ENGINEERING CHANGE NOTICE

This ECR describes changes in PCI Express graphics cards keepouts necessary to support card retention solutions.

PCI Express Card Electromechanical Specification 1.0a

Figure 6-3: Additional feature and keepouts on x16 graphics card

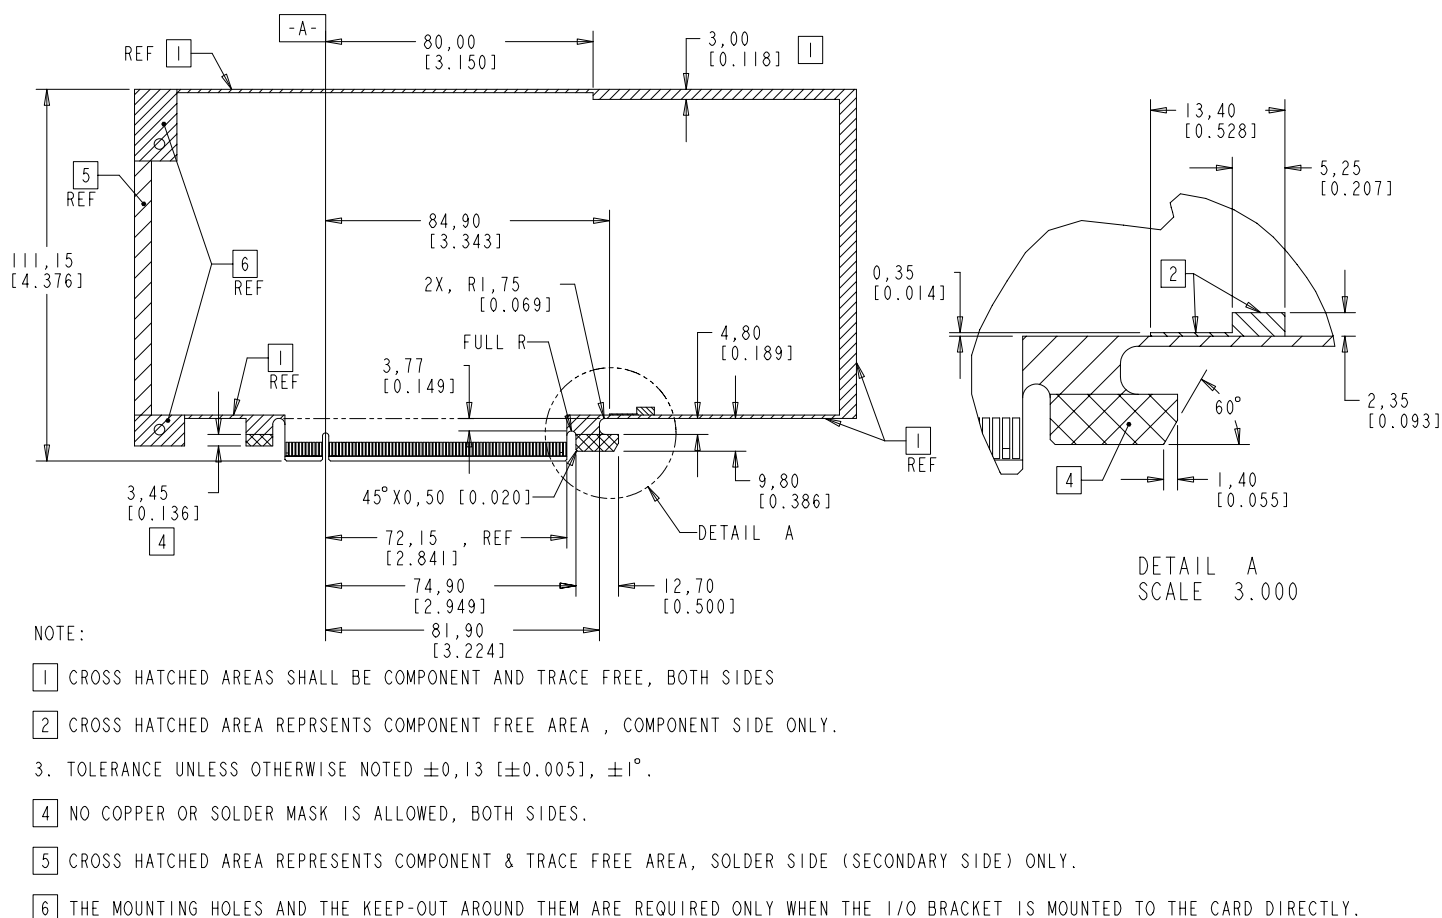
Special attentions shall be given to graphics cards because of their potential high mass, driven by the high power allowed. This specification defines the additional feature and keepouts on the x16 graphics cards for card retention, as shown in Figure 6-3.

The 3.0 mm keepout on the top of the card is to accommodate system or chassis level card retention solutions at each OEM's discretion. To facilitate a chassis level retention solution, the height of the standard height graphics card is required to be fixed: 111.15 +/-0.13 mm. Low profile graphics cards do not require the 3.00 mm keepout.

The “hockey stick” shaped feature and keepout defined on the bottom of the card is to allow retention mechanisms either mounted directly on the system board or integrated into the x16 connector. This feature and keepout are also required for the low profile graphics card.

All retention mechanisms that are intended for the x16 graphics cards must use the feature/keepout defined in Figure 6-3. But the specific retention mechanism design is system manufacturers’ choice. Reference retention mechanism designs are given in the PCI Express Graphics Card Thermal and Mechanical Design Guideline for Desktop Systems.

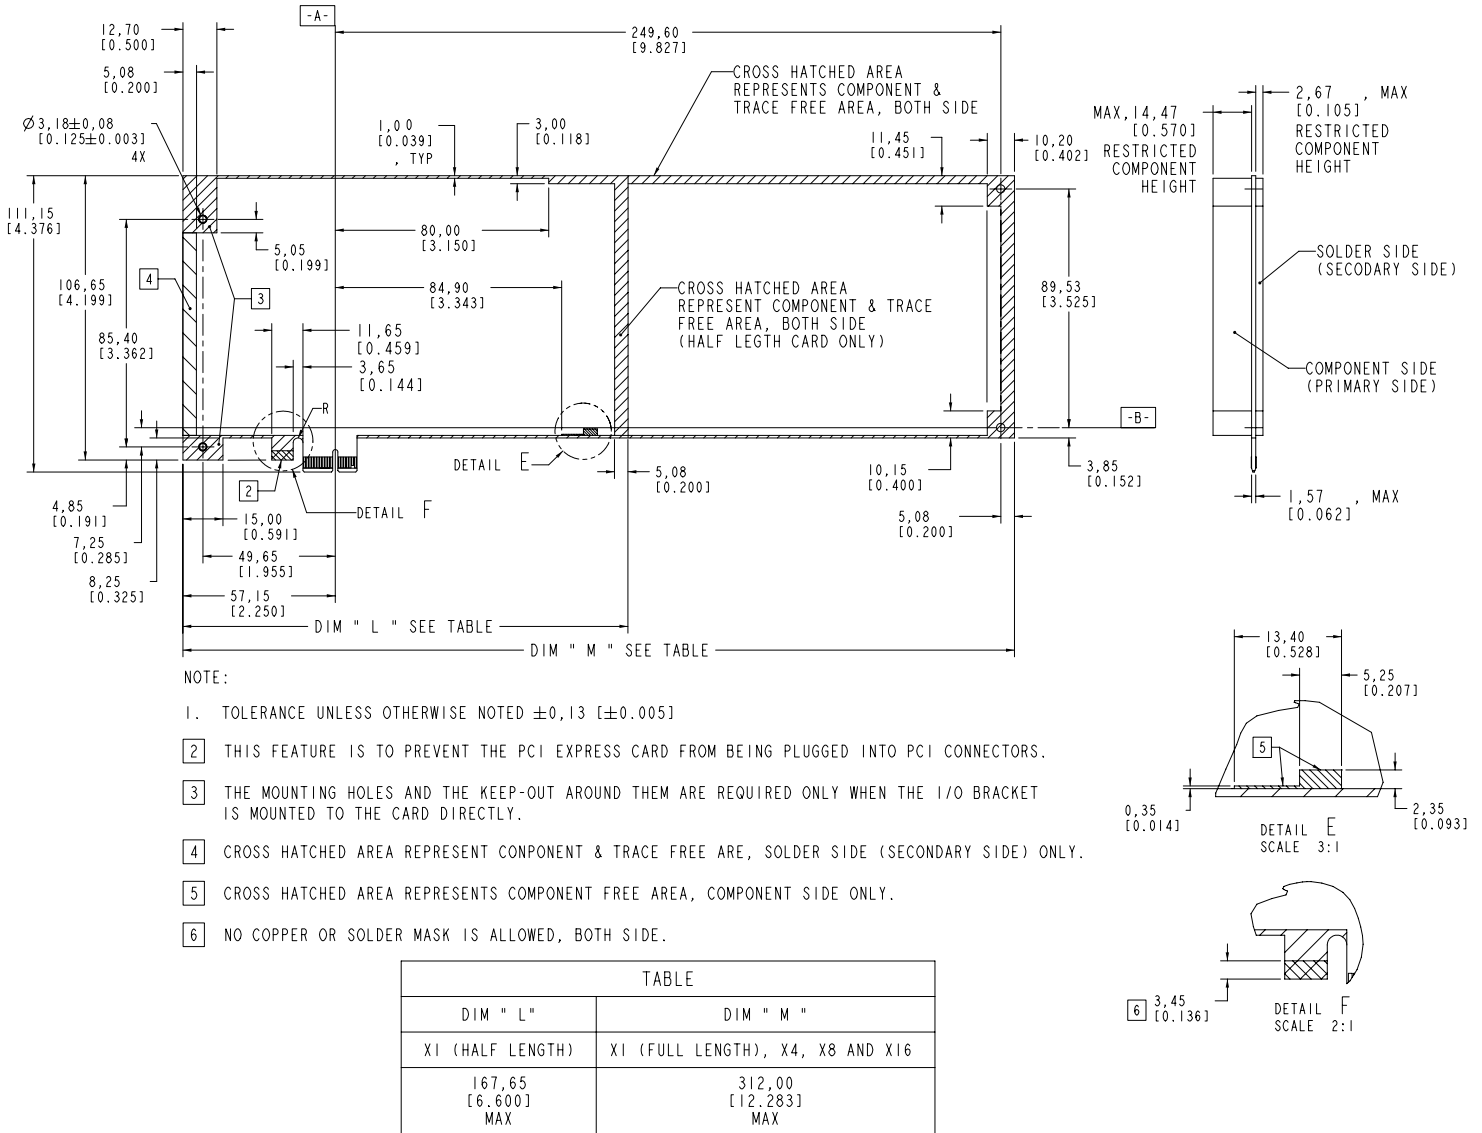
- Replace Figure 6-1 (standard height card) in Page 68 with (added a keepout marked in Detail E to avoid potential component interference with the graphics card retention mechanism when up-plugging; also, fixed the height to 111.15+/-0.13):

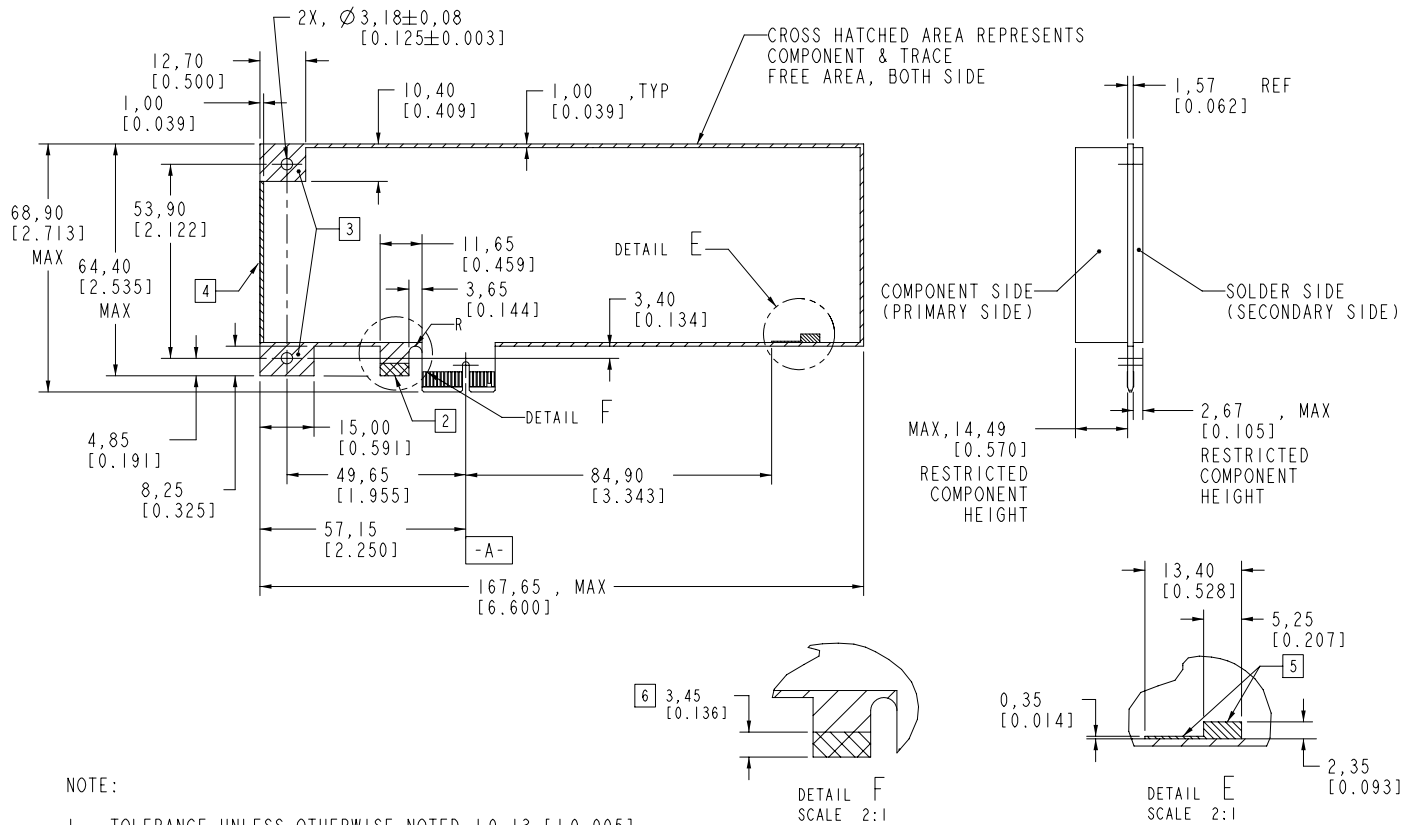
- Replace Figure 6-6 (low profile card) in Page 73 with (added a keepout in Detail E to avoid potential component interference with the graphics card retention mechanism when up-plugging):
